Site Survey of Selected Items
for
Compliance with the Americans with Disabilities Act
(ADAAG)
and
Title 24 of the CBC

The site survey of Woodrow Wilson High School was conducted on February 27, 2007 during a spot check for compliance with the Americans with Disabilities Act Guidelines (ADAAG) and Title 24 of the CBC

Facility Name: Woodrow Wilson High School

Girls Restroom next to the Small Gym

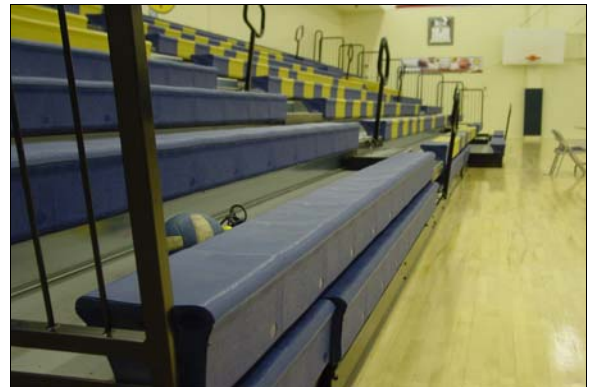
Finding: The toilet paper dispenser interferes with the use of the side grab bar.

Full Rec Remount the toilet paper dispenser so it does not interfere with the use of the side grab bar and is within 12 inches of the front edge of the toilet.
